PROJECT EVALUATION:

The applicant is requesting a Planning Director's Special Permit in order to construct a second single family residence on the existing .23± acre lot which is currently developed with a single family residence. The proposed unit is 978 sq. ft., and is proposed to be a two bedroom, one bath home with an attached two car garage.

P90-332

EXHIBIT - C  
FLOOR PLANS

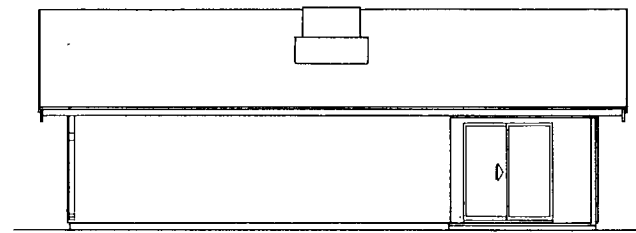
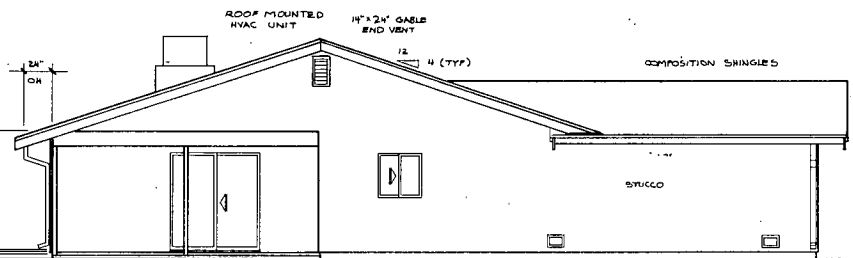
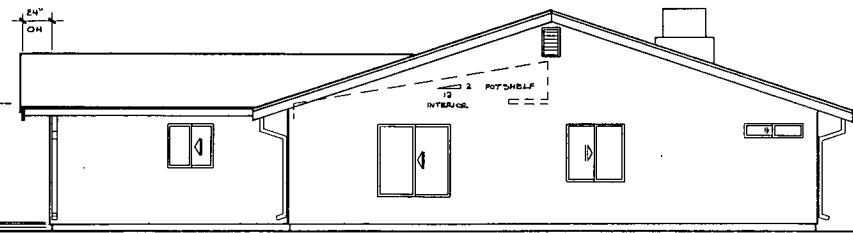
The design of the two bedroom, one bath and two car attached garage which is being proposed is similar in design to the existing single family residence on the subject site. The applicant is proposing a stucco exterior (terra cotta/tan) with wood trim and a composition shingle roof. The front door and the garage door on the existing single family residence are metal doors with panels. Staff recommends that the same type of doors be used on the proposed residence. The roof material to be utilized on the proposed unit is composition shingle. Staff recommends that a laminated dimensional shingle with a minimum 25 year rating be used.

1. The roof material shall be 25 year laminated dimensional shingles;
2. The design of the unit shall include the following:
  - a) The front door shall be panelled metal with a minimum of six panels;
  - b) The garage door shall be a metal sectional roll up door; and
3. The applicant shall obtain all necessary Building Permits.
4. The applicant shall submit a revised site plan indicating the reduction of pavement in the front yard are so as not to exceed the allowed 40% .
5. The applicant shall contact the City Planning Department for a site inspection upon completion of the proposed unit and prior to the final building inspection.
